CHANGE ORDER

Project: Woodland High School Project No.: 1119.00-12
 Architect: McGranahan Architects Change Order No.: 2
 Contractor: Skanska USA Building, Inc. Date: February 9, 2014

CONSTRUCTION CHANGE DIRECTIVE: 002 R1

Woodland High School

A2.01

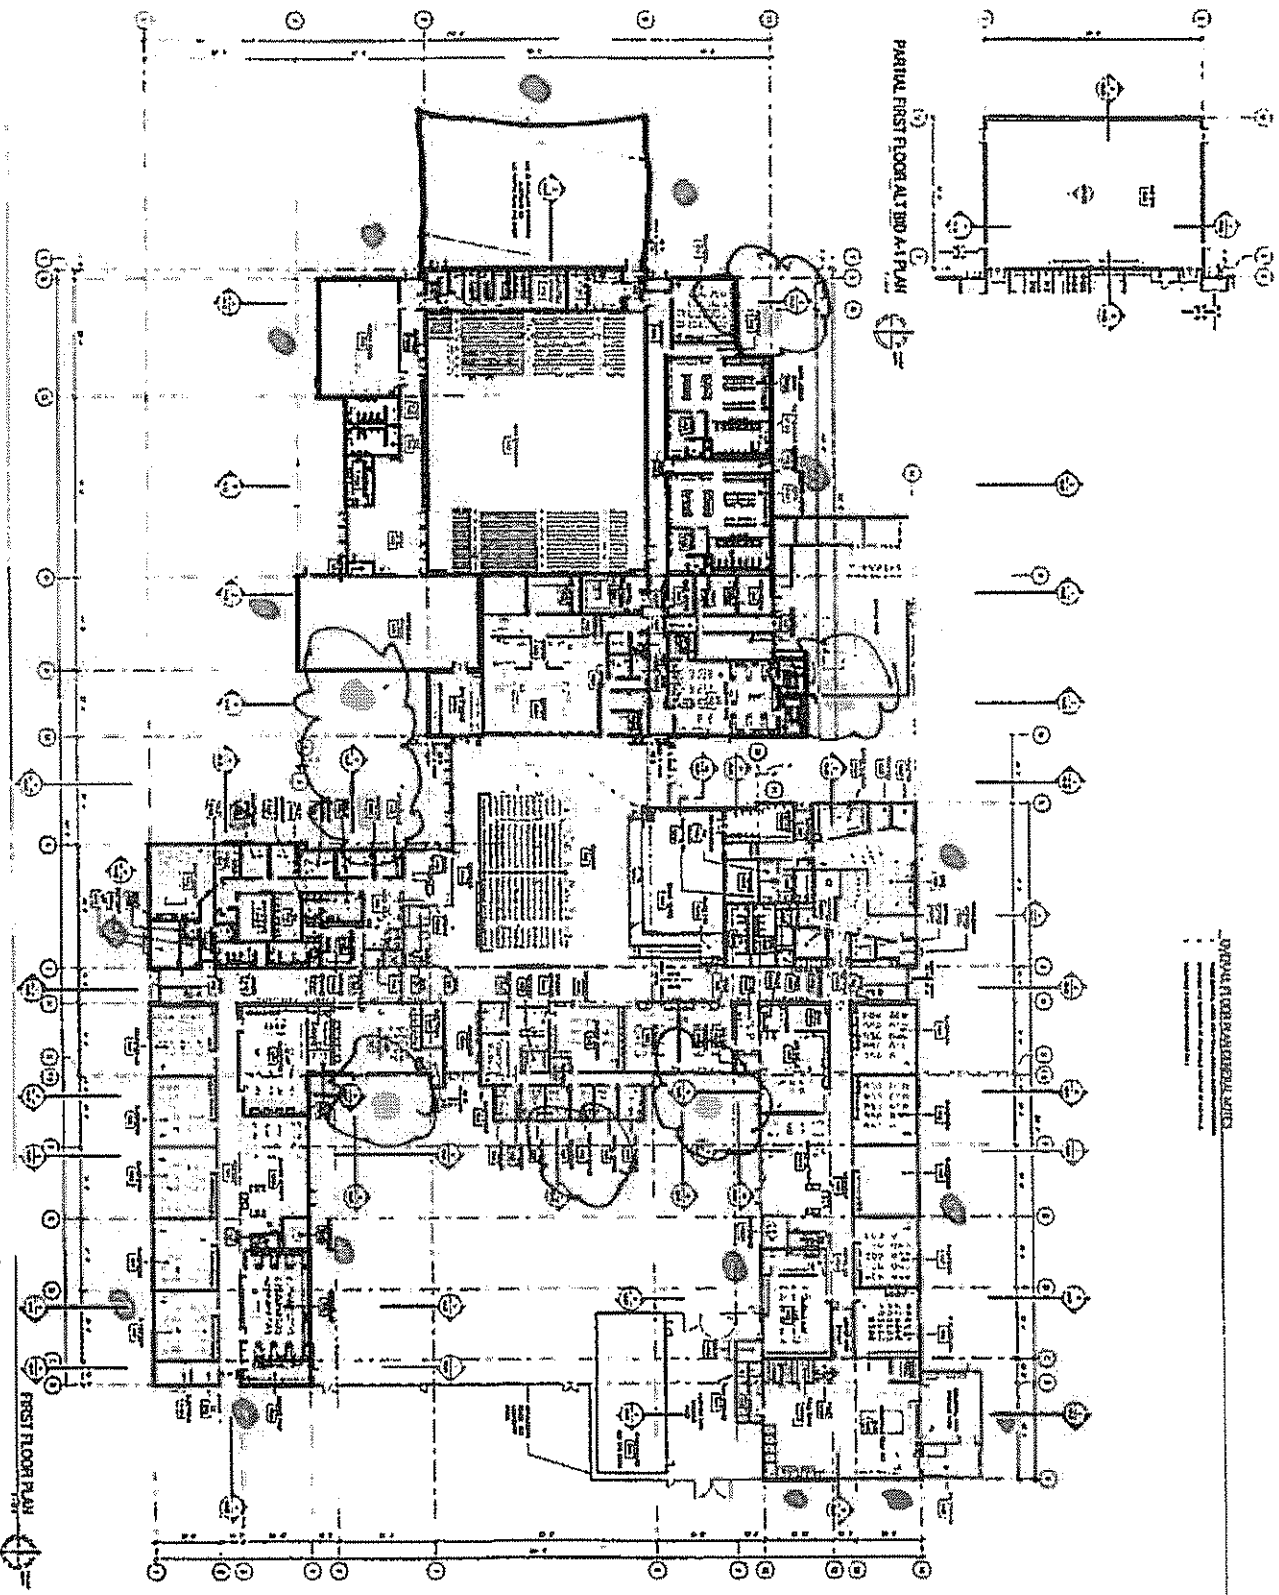
1. Geo-Grid installed during Phase 1 was shown to extend 10'-0" from phase of building. Pothole at locations shown on the attached plan to verify that geo-grid was installed. ~~It is acceptable to locate just the upper layer of geo-grid.~~ Locate both layers of geo-grid.
2. Where geo-grid is located, verify as-built elevation of the upper layer.
3. Notify McGranahan with results as work proceeds.

Clouded pink locations added 1/17/14

TITLE: LEVEL 1 - PLUMBING PLAN - CULINARY ARTS REVISION
 REFERENCE: 2 / M2.15
 SCALE: 1/8" = 1'-0"
 ISSUED FOR: RFI - 0058
 DATE: 02/03/14

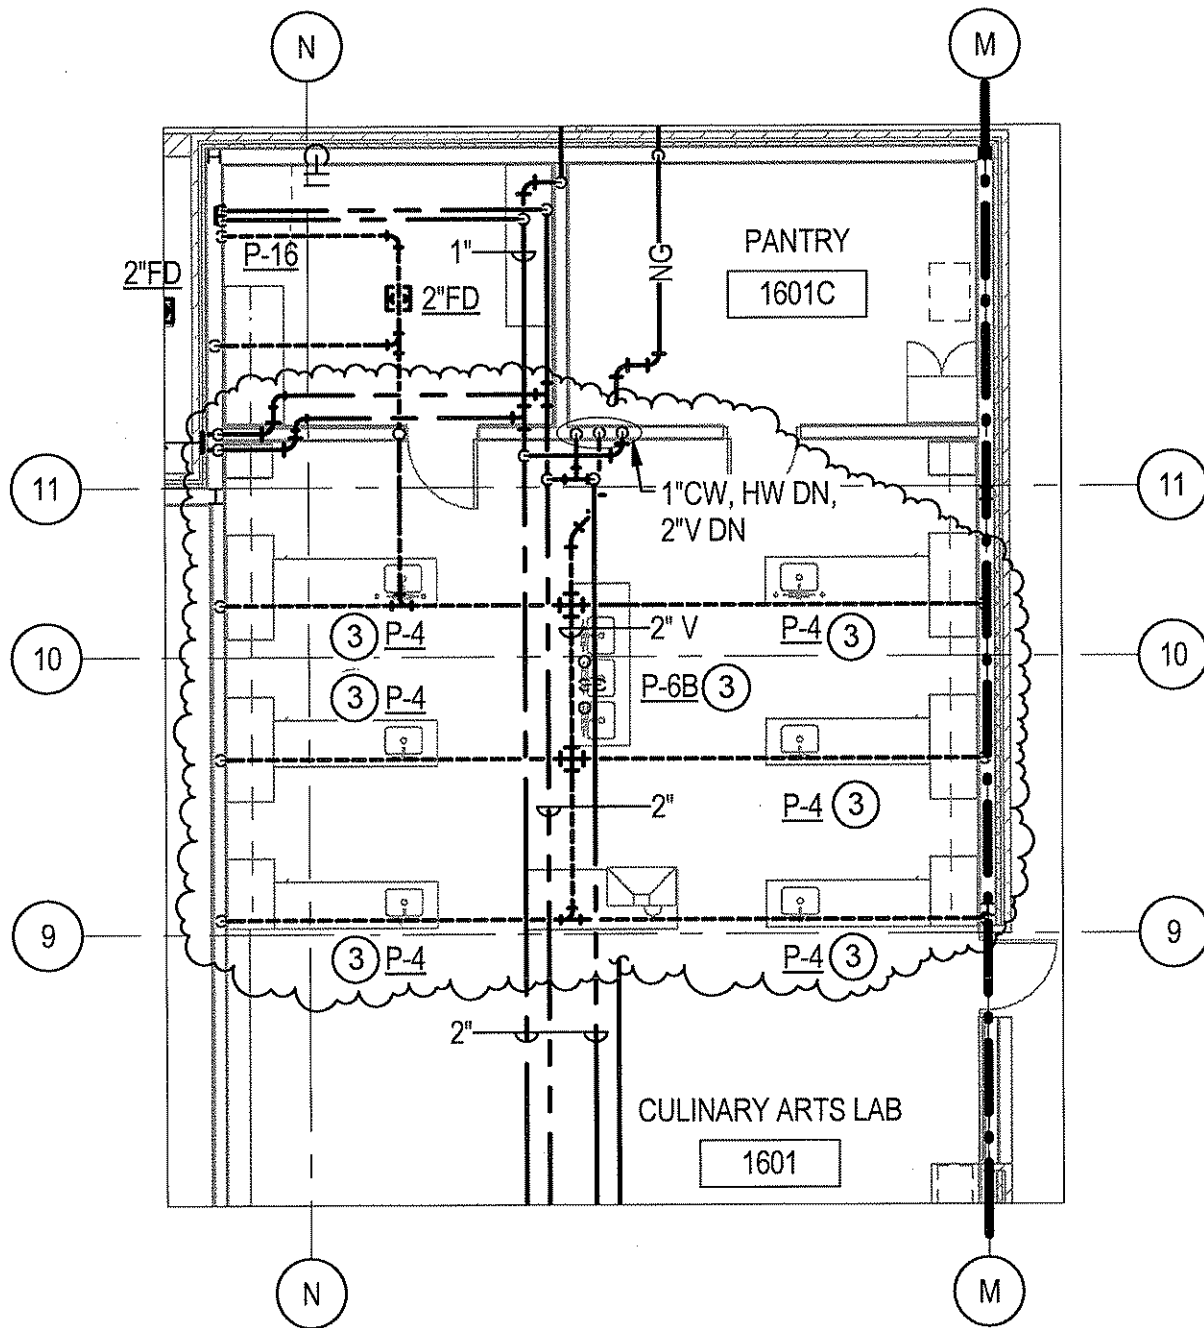
Reference sheets A2.17 and M2.15.

The plans on M2.15 construction note 2 indicate that the piping that serves the sinks at the ends of the peninsula cabinets is concealed in the cabinets. It appears that this will interfere with the dishwasher and cabinet drawers that are being installed next to the sink (A2.15). Will a chase be provided for the plumbing?

Route vent and water piping underground as indicated on sketches MSK-081 and MSK-082.

ISSUED FOR: RFI #036

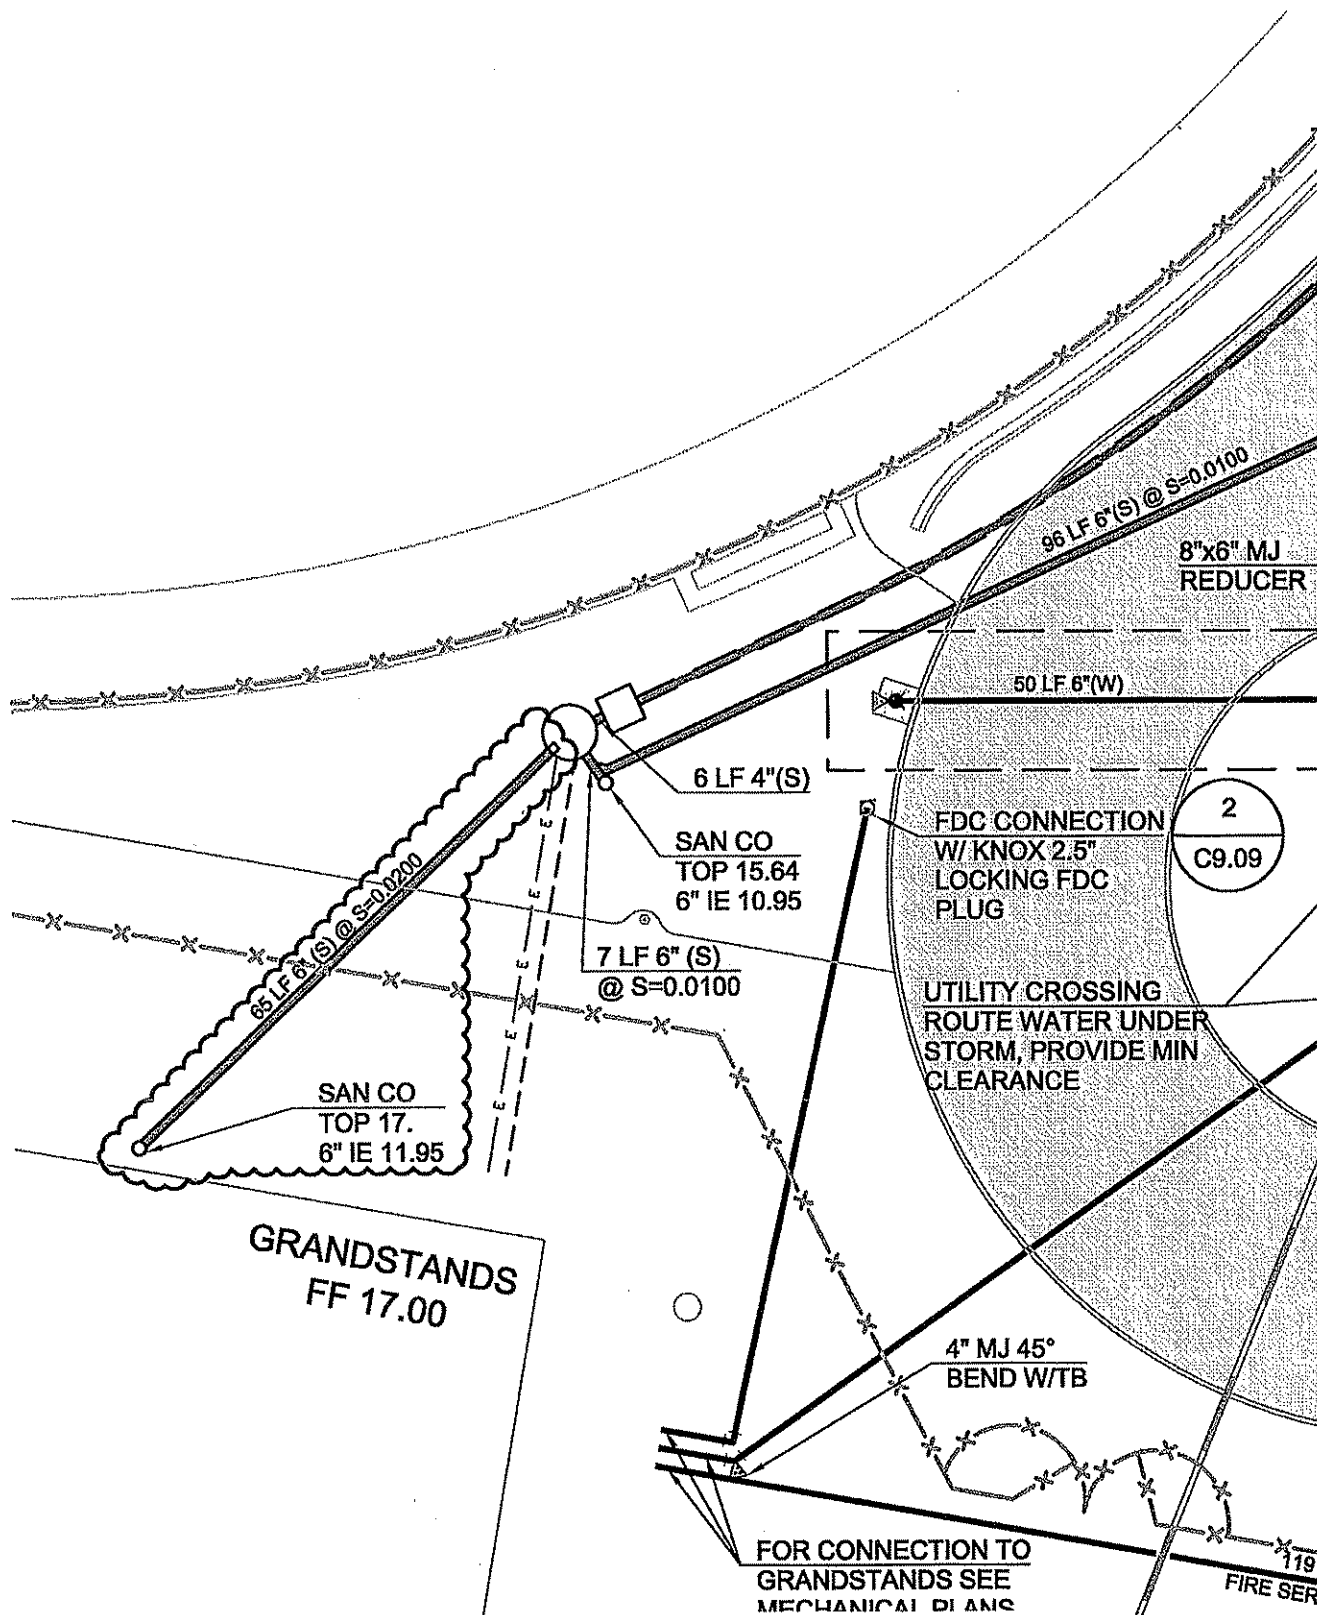
There is a sanitary sewer line leaving the grandstands near gridlines AC-AD/A5 with a note that it is to sanitary sump pump. At gridline AA/A5 there is a vent line coming to the building which appears to be the vent for the pump station. The civil drawings show a sanitary sewer line routed to the approximate location of the vent line at AA/A5 but there is no sanitary sewer piping shown to the sewer line leaving the grandstands near gridlines AC-AD/A5.

Please clarify and/or provide revised plans showing correct sanitary sewer piping at grandstands.

Tapani Inc. would like to present the following cost proposal for the additional work required to construct the sanitary sewer line detailed in CSK-028 in the response to RFI 0036. The original plansheet C6.07 called out 46 LF and the revised plan CSK-028 calls out 65 LF. The net increase is 17 LF.
